PIKE SOLAR

GRADING, EROSION & SEDIMENT CONTROL PLANS

EPC STORMWATER REVIEW COMMENTS ARE SHOWN IN ORANGE BOXES WITH BLACK TEXT

PCD-ENGINEERING REVIEW COMMENTS IN BLUE BOXES WITH BLUE TEXT

SHEET
 4 OF 77

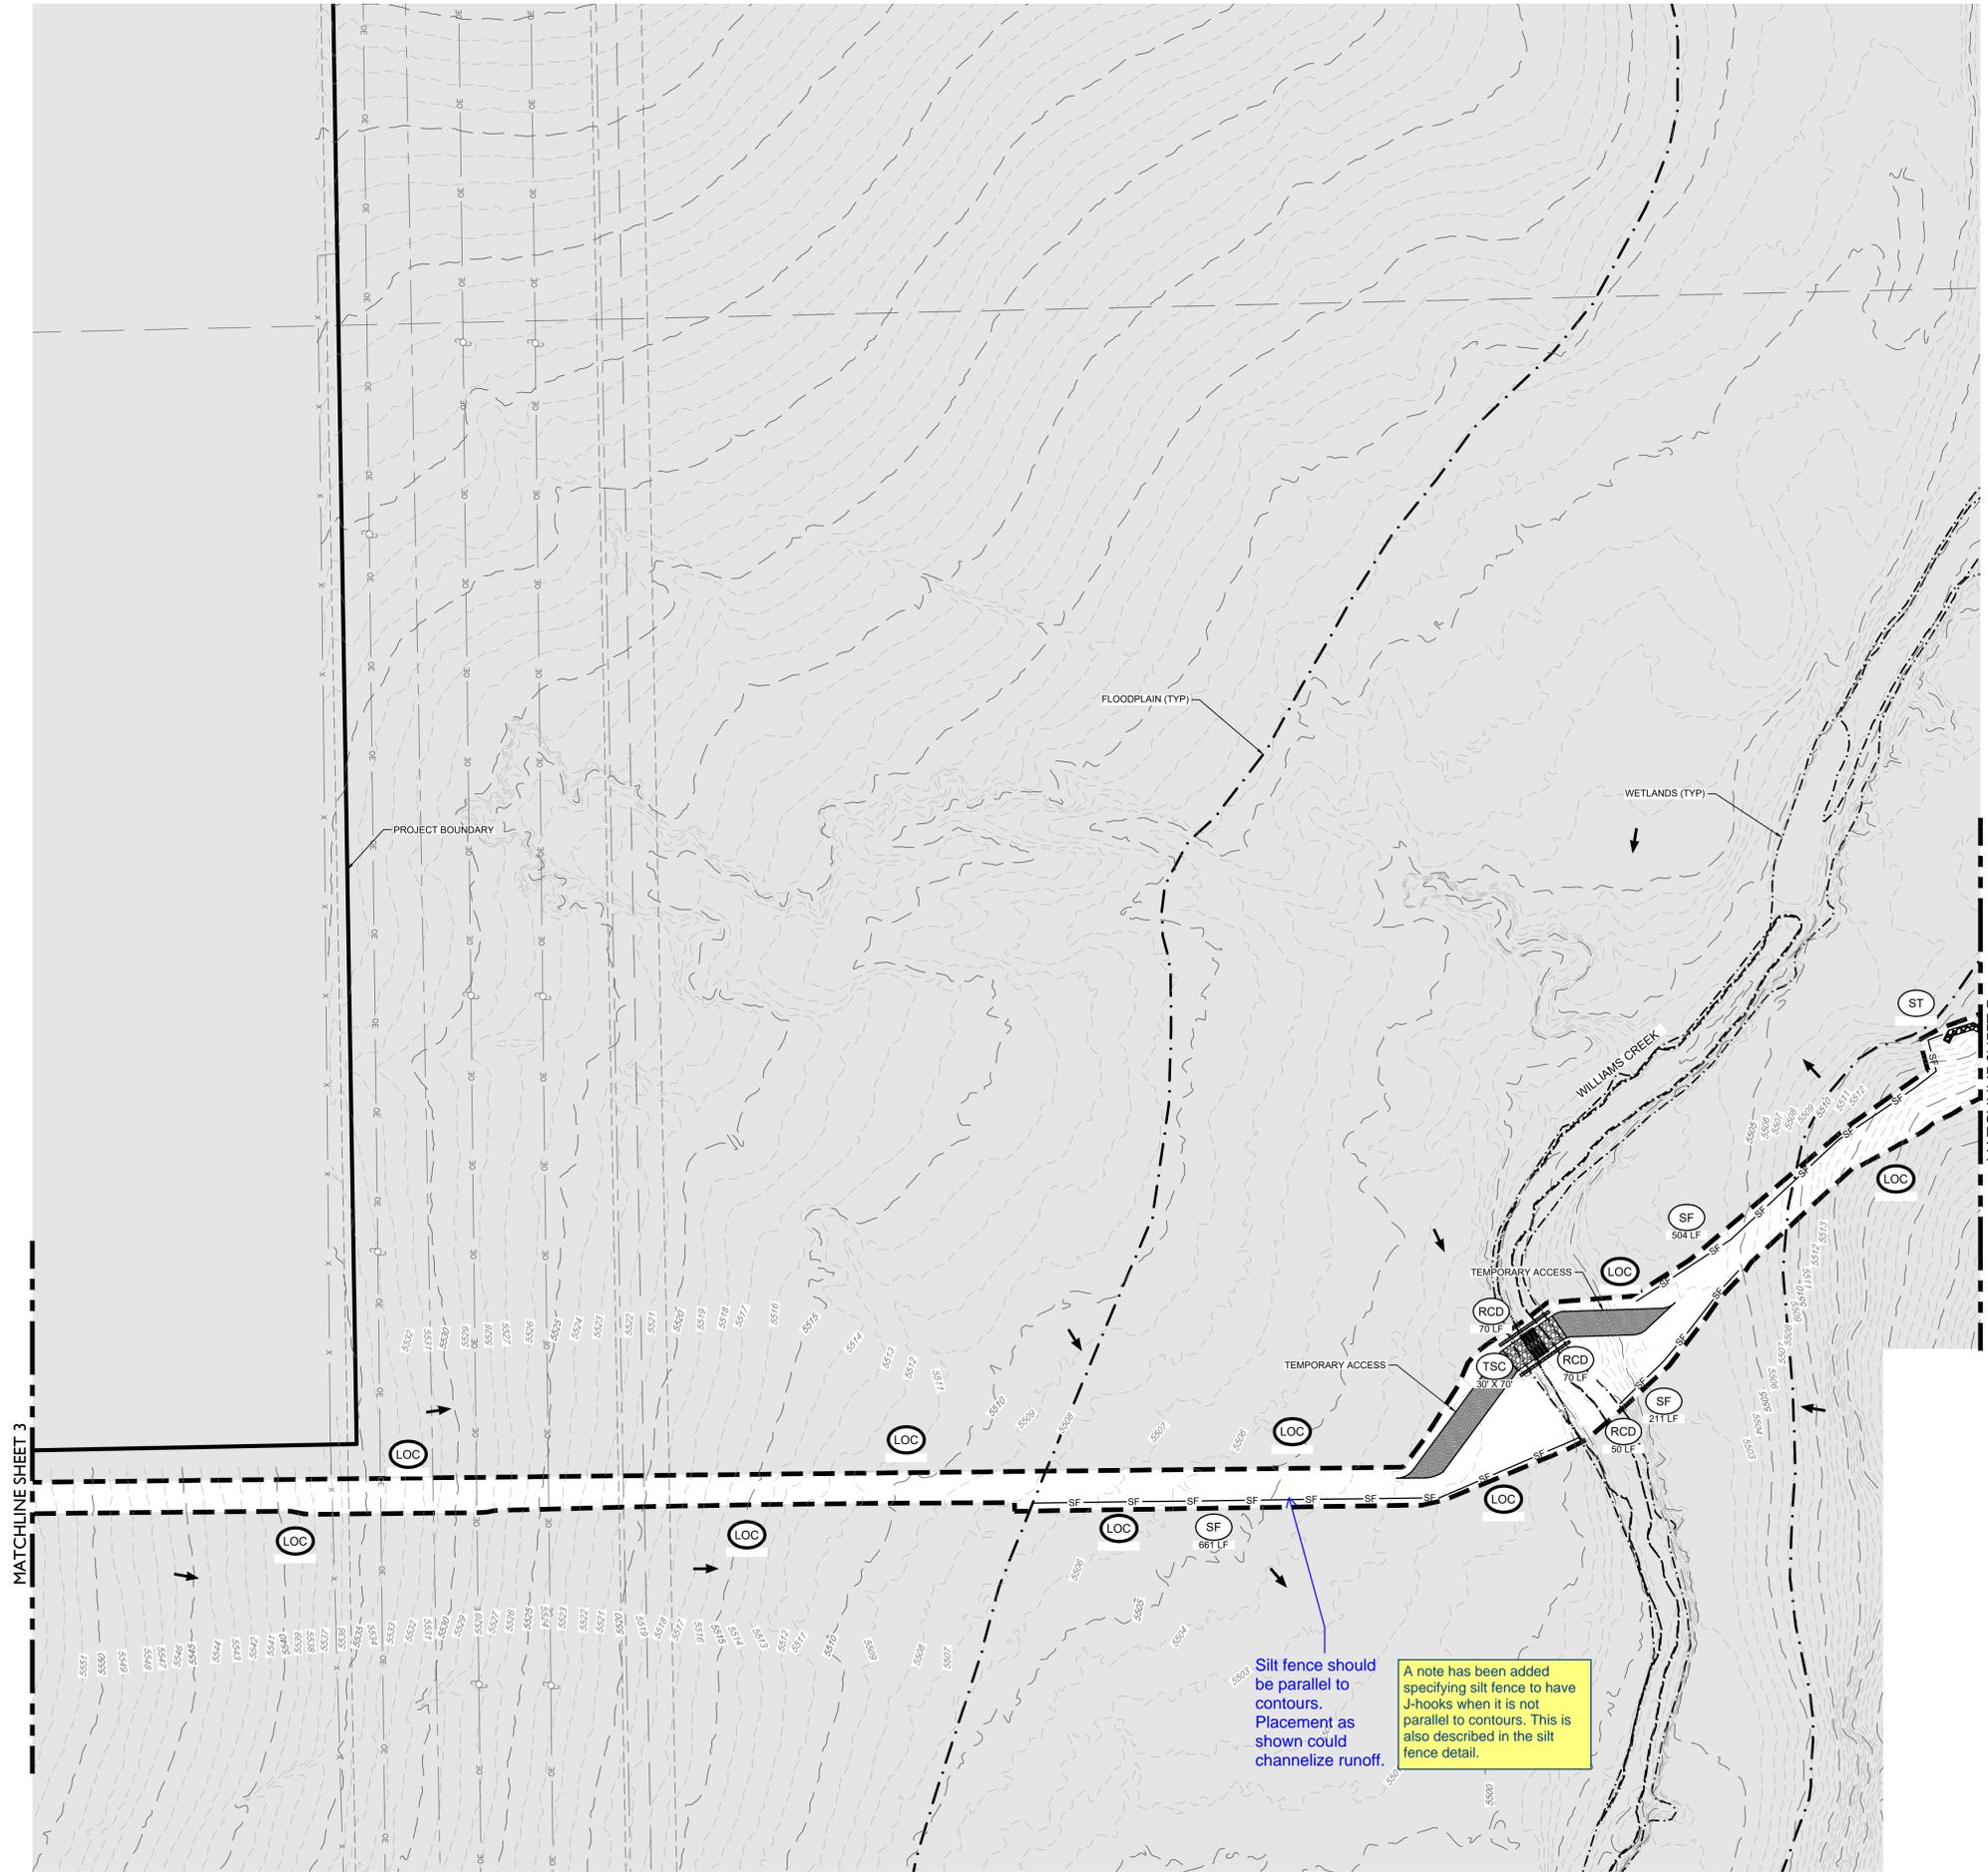
Silt fence should be parallel to contours. Placement as shown could channelize runoff.

A note has been added specifying silt fence to have J-hooks when it is not parallel to contours. This is also described in the silt fence detail.

SHEET
5 OF 77

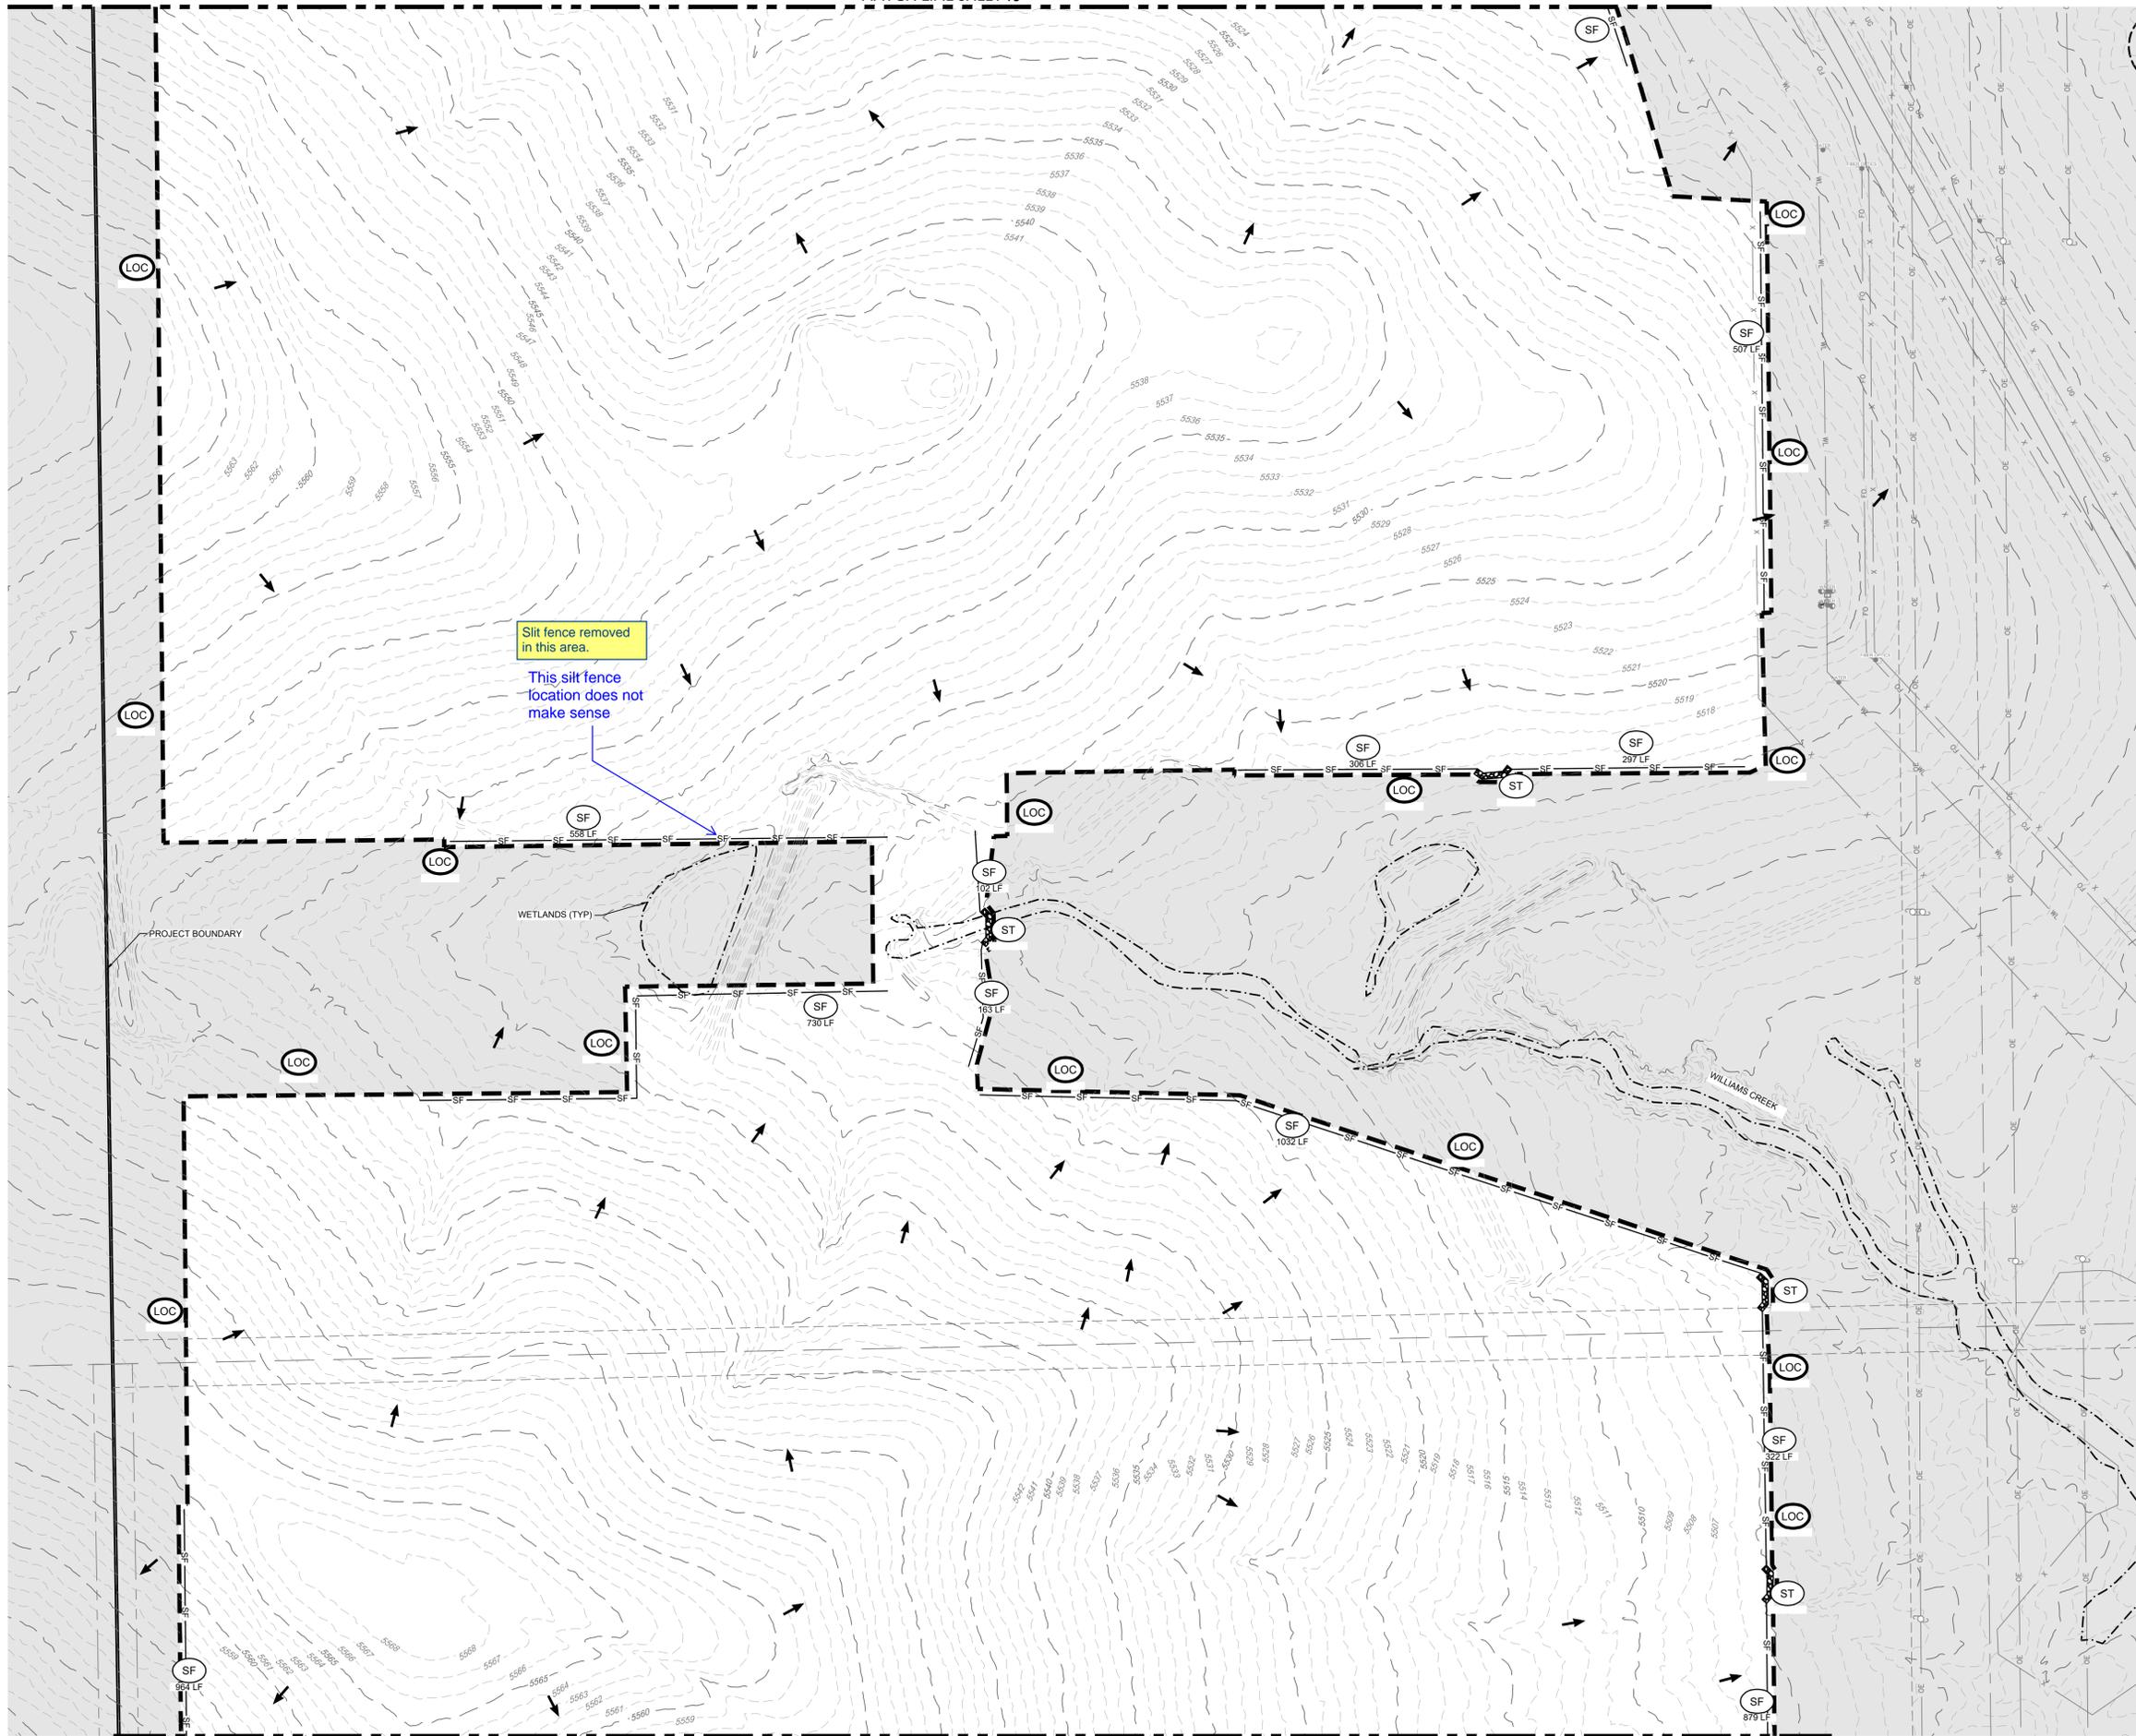
Sediment traps are not appropriate for this application. Temporary sediment basins should be used for tributaries greater than 1 ac. (typ.)

This sediment trap has been replaced with a temporary sediment basin.

JOB NO.
20-194
SHEET
33 OF 77

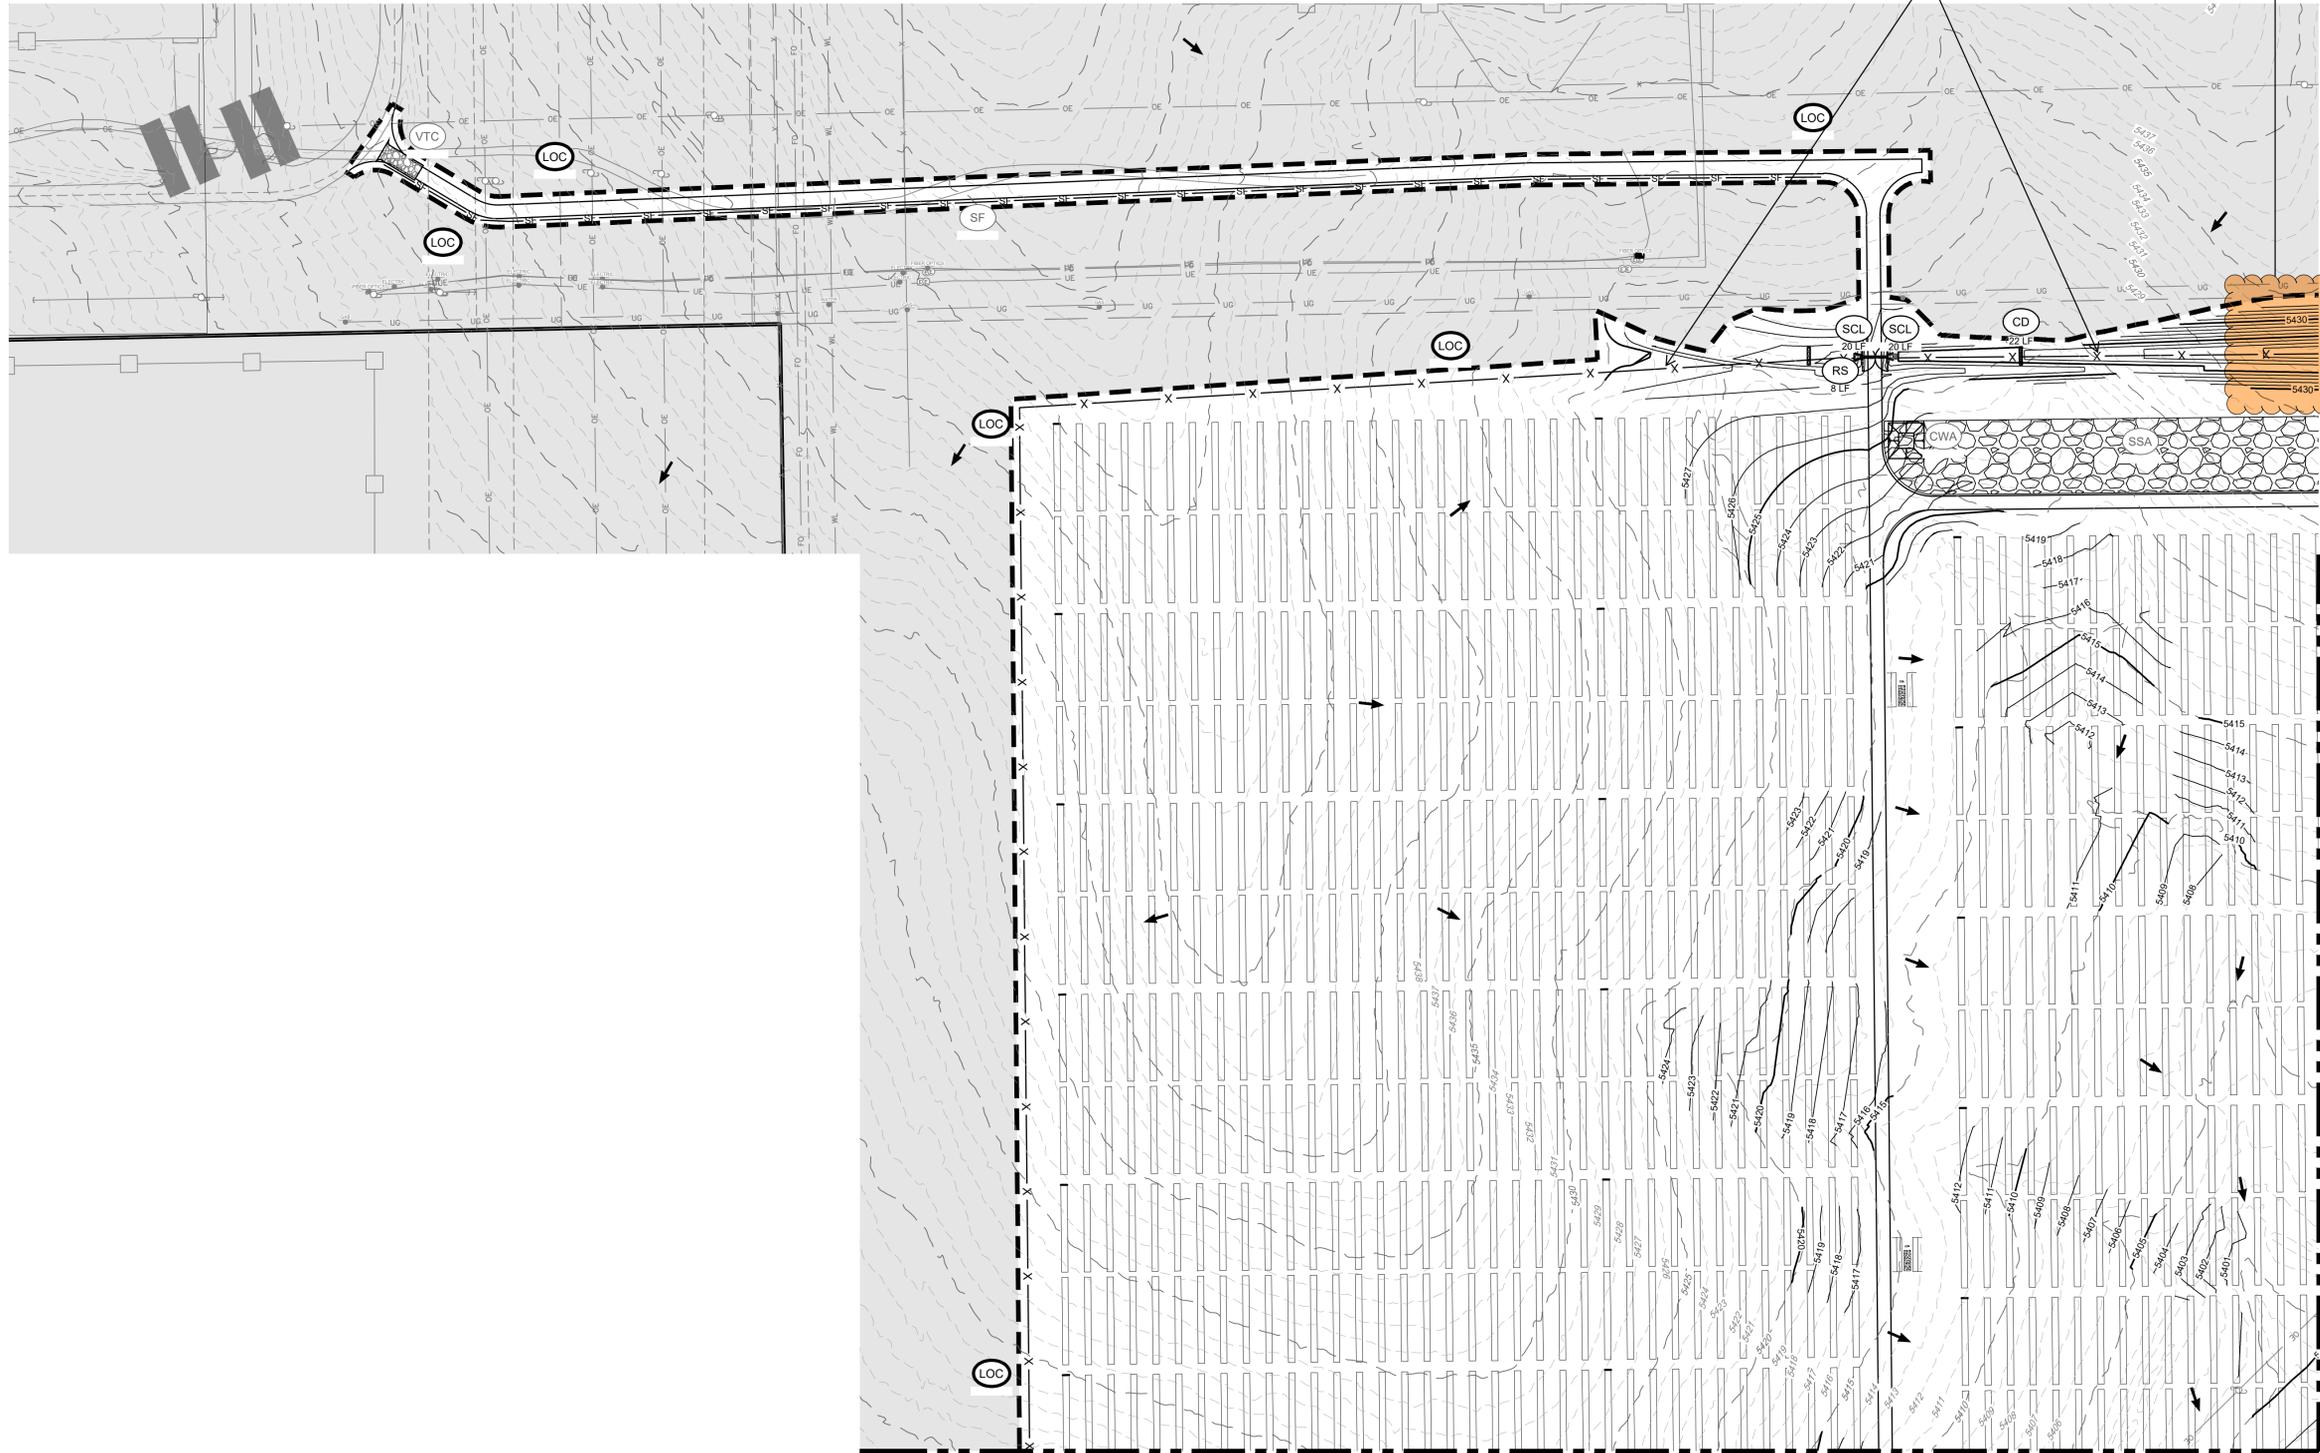
Silt fence with J-hooks? (flow along silt fence is going to be channelized)

A note has been added specifying silt fence to have J-hooks when it is not parallel to contours. This is also described in the silt fence detail.
